Product change notification (PCN)

Title / short description	SACC with Screw Connection - Change to leadfree
Affected article category	Sensor/actuator cabling
Change category	Material, Form and appearance
Change number	CAF260072-00
Reason for PCN/PDN Revision

Product change notification – CAF260072 SACC M12 Screw Connection (M12 8pos. + M12 SH 4pos. 5pos)

Change to leadfree

Small optical differences:

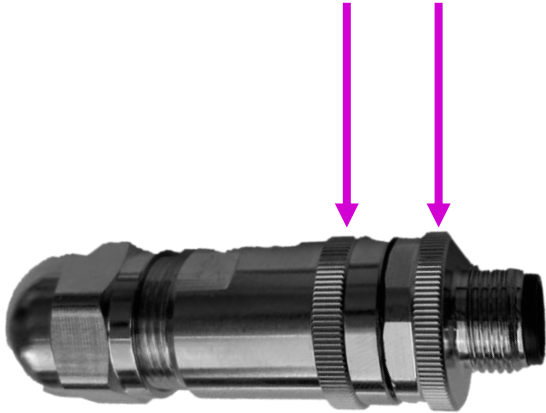
- The knurling was chosen a bit coarser for better manufacturability and better handling for assembly
- The color of the connectors (surface) is more dull and darker (no more brass coating; not so shiny)

Change to leadfree

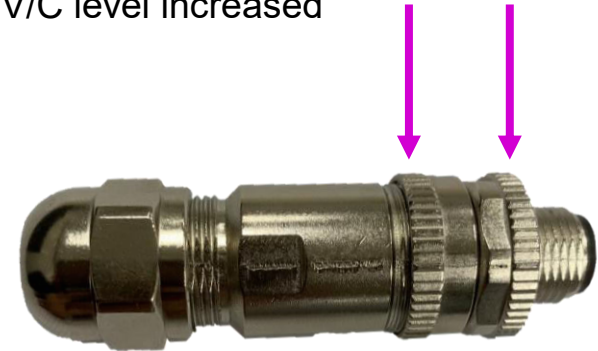
Old:

Lead containing:

- Shiny coating
- Fine knurling

New:

Leadfree:

- ensures long-term compliance
- RoHS without exceptions
- Other visual color surface
- More coarser knurling (better manufacturability and handling for assembly)
- V/C level increased
